Date: August 9, 2021
To: Waterford Conservation Commission

Re: Application #C-21-08: 908 Hartford Turnpike
Multi-Unit Residential Development
Application Materials Review Comments

Scale: 1"=200 ft.
2016 Aerial Photo

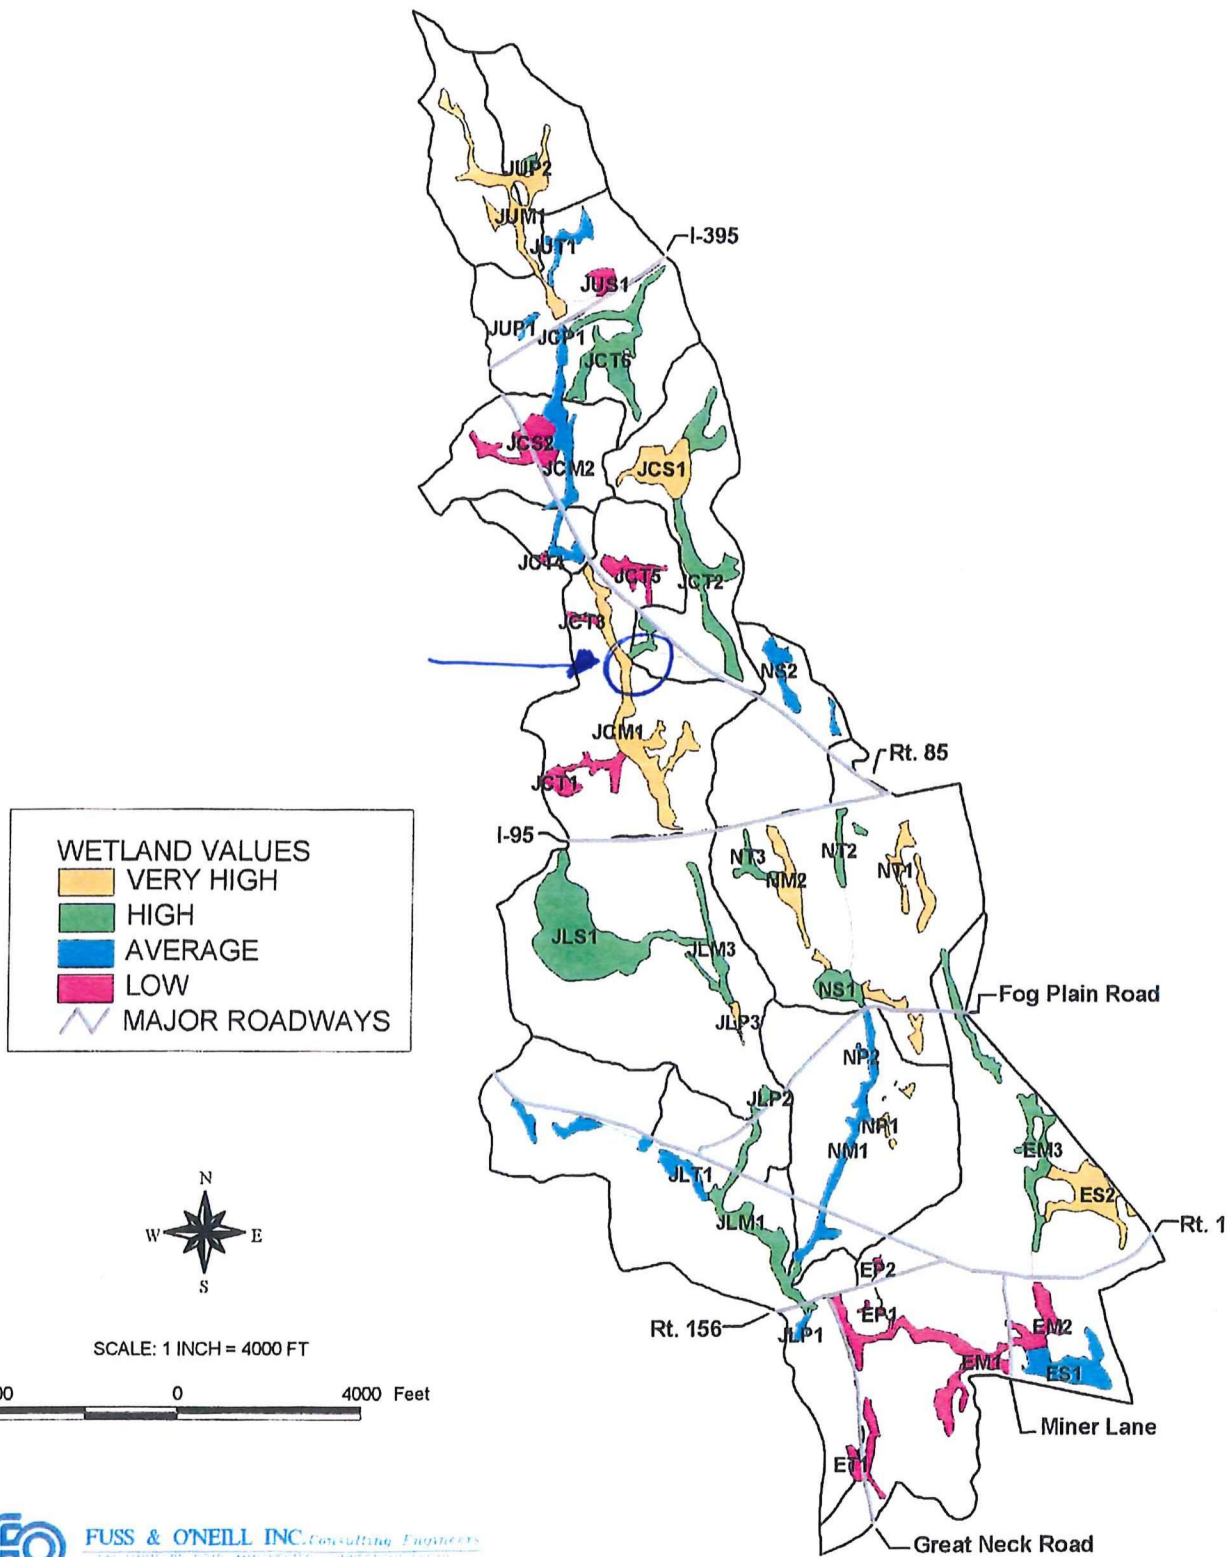
The majority of the property consists of forested upland. Refer to attached aerial photo and watershed wetland summary information.
